Service Bulletin

Alternative three blade propeller installation

SB-GA8-2009-62

Issue 34

Figure 1

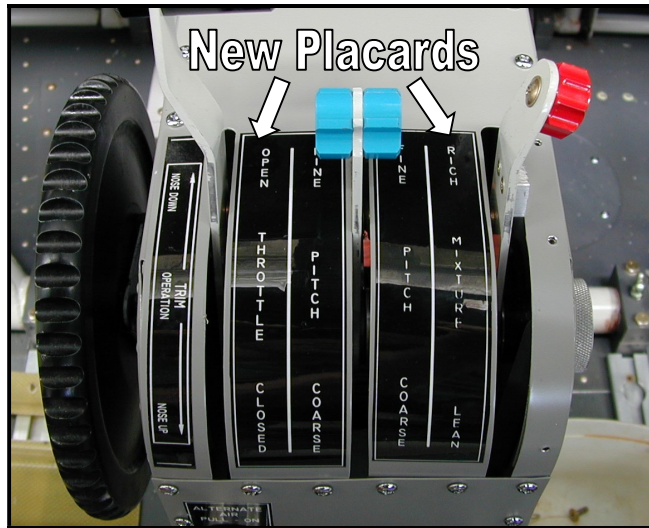
1. Remove three screws securing the under-dash kick panel and remove to gain access to the rear of the instrument panel.
2. Replace the existing tachometer with the new tachometer P/N GA8-771013-15 (CASA) OR GA8-771013-9 (FAA).
3. Reinstall the under-dash kick panel.
4. Remove the existing pitch stop (P/N GA8-761021-63) and throttle quadrant placards and install new placards as shown below.³

Figure 2

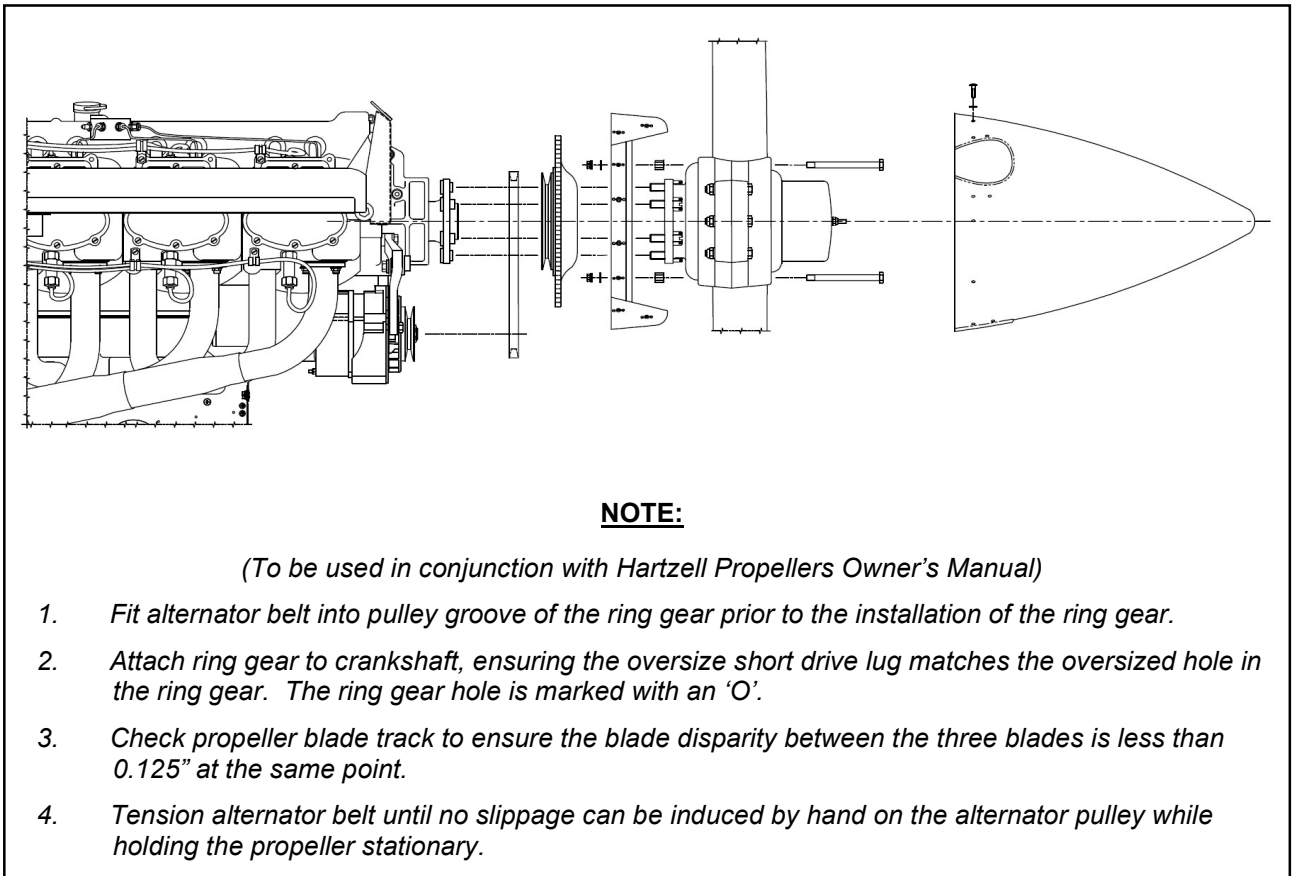
5. Remove the cowls.
6. Install three blade propeller in accordance with the Hartzell Propellers Owner's Manual (Manual No. 115N, Section 3) at latest revision and illustration in figure 2.
7. After installation of three blade propeller ensure that the fine pitch blade setting is set at $12.8 \pm 0.2^\circ$

Figure 4

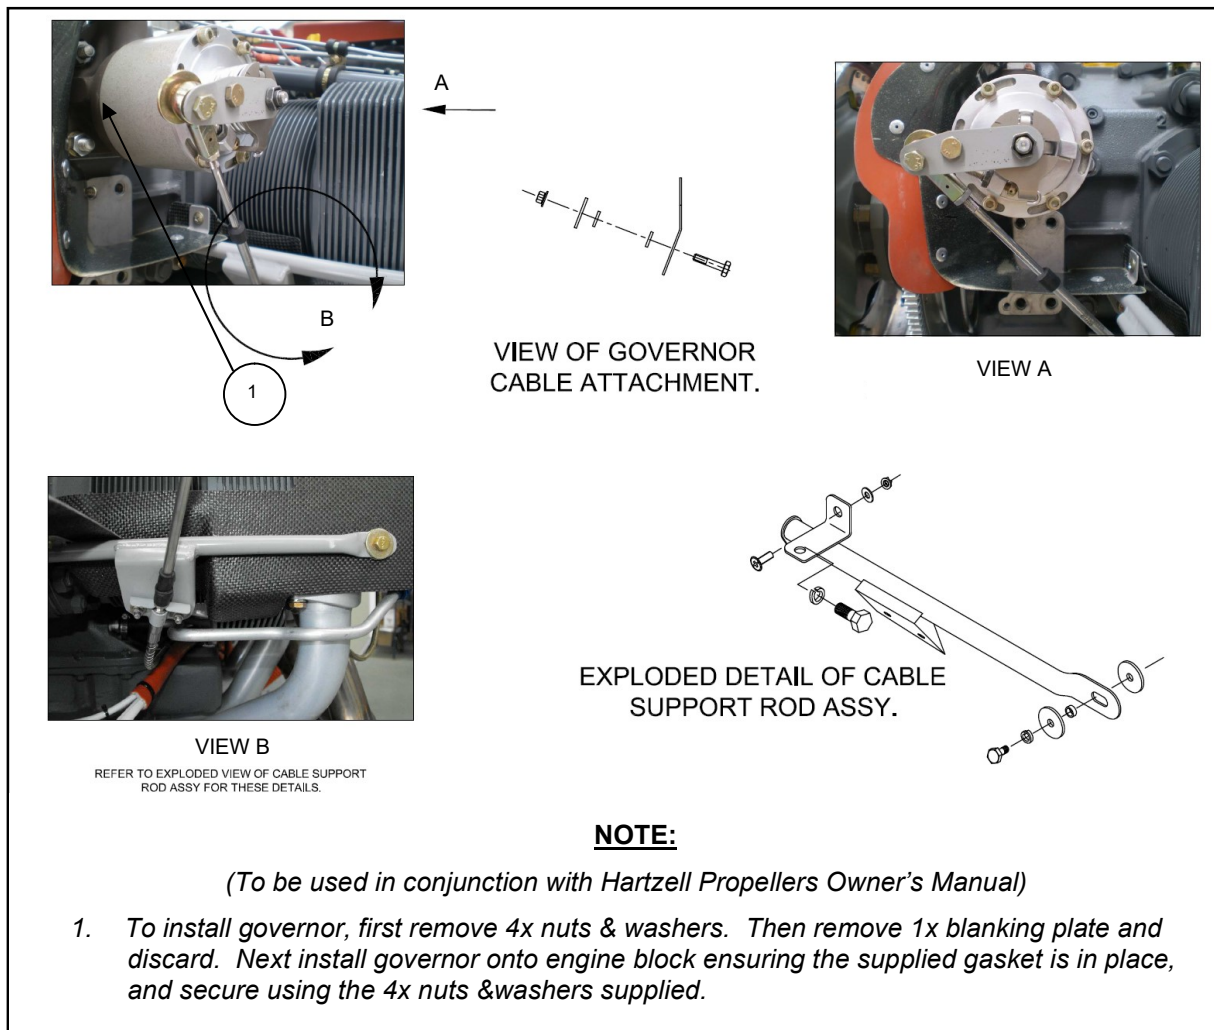
8. Replace 4 Governor attachment studs with P/N 31C-17, inserting new studs to the same depth as original's.
9. Install governor in accordance with Hartzell Service Letter HC-SL-61-277 at latest revision and illustration in Figure 3.
